***Ducted Systems
Technical Services
Service Tips Letter***

Letter: **ST-014-2018**

Subject: **3-12 ton Packaged Reheat – Resolution of 3-way valve issue.**

Product: **Series 10, Predator, Outfitter, Ovation, ReliaCore 300, OmniCore 300**

Figure 1.

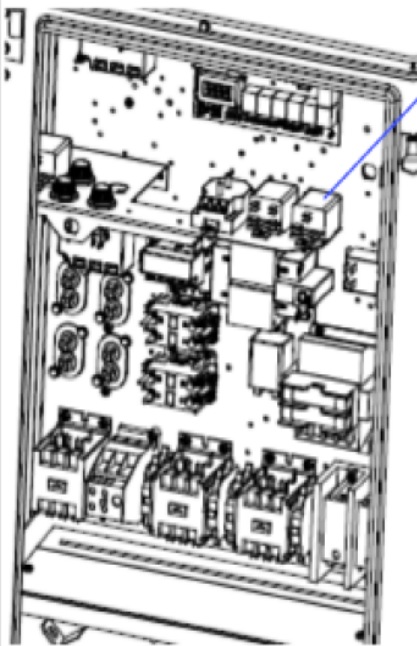
1. Open the controls access door and locate the reheat relay, as shown in Figure 1
2. Disconnect all wires from the reheat relay and remove the (2) screws securing the reheat relay. Discard relay

3. Install the new reheat relay DPDT, secure using (2) screws removed from previous step
4. Install ICM102 time delay relay
5. Connect wiring as described in steps 6 thru 13, refer to Figure 2 below as needed

Figure 2.

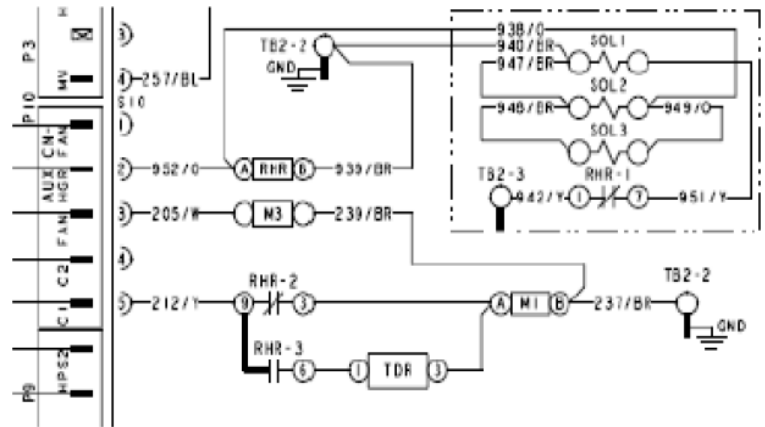
The following instructions are to provide direction to replace the current RHR (SPDT) with a (DPDT) relay with the addition of a Time Delay Relay. The purpose of this change is to provide a brief interruption of the compressor at the initiation of a call for dehumidification only and allow the Reheat Valve to fully shift to the reheat mode.

6. Connect wires 938/O and 952/O from UCB-AuxHGR and SOL2 to terminal 'A' on the new RHR relay
7. Connect 939/BR from TB2-2 to terminal 'B' on the new RHR relay

8. Connect 951/Y from SOL1 to terminal '7' on the new RHR relay
9. Connect 942/Y from TB2-3 to terminal '1' on the new RHR relay
10. Disconnect 212/Y for compressor contactor M1-A and re-connect to terminal '9' on the new RHR

11. Connect a new wire from compressor contactor M1-A to terminal '3' on the new RHR relay
12. Connect a new wire from terminal '1' on ICM102 to terminal '6' on the new RHR relay

13. Connect a new wire from terminal '3' on ICM102 to compressor contactor M1-A, since there may be only one terminal available on M1-A, a piggyback terminal may be required
